SERVICE INFORMATION BULLETIN

APPLICABILITY: 2026+ Outback 2.5L
 2026+ Impreza & Crosstrek 2.5L
 2026+ Forester

NUMBER: 18-243-26
DATE: 06/10/26

SUBJECT: FB2.5 Oil Spacer / Service Manual Correction

4. Install the oil spacer to the cam carrier

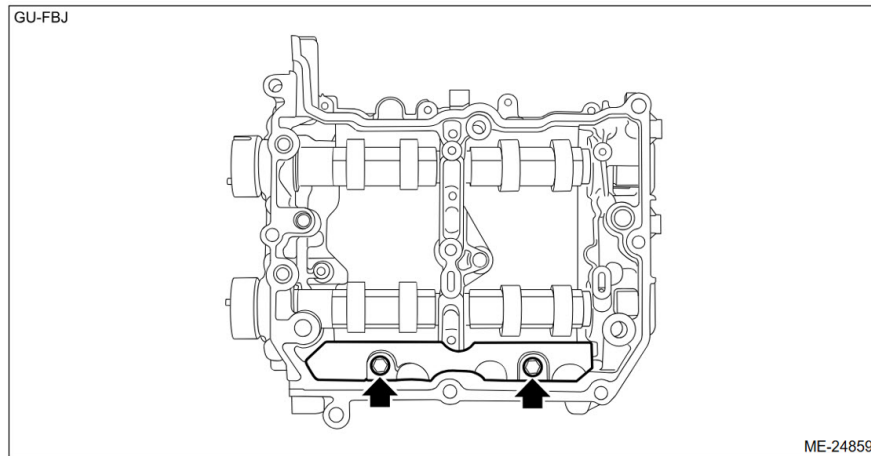
Some FB2.5 engines removed oil spacers from production. If oil spacers are missing during camshaft carrier servicing, there is no need to install new ones. If the engine has oil spacers and they are removed during servicing, reinstall them as per the applicable Service Manual.

Tightening torque:

6.4 N·m (0.7 kgf-m, 4.7 ft-lb)
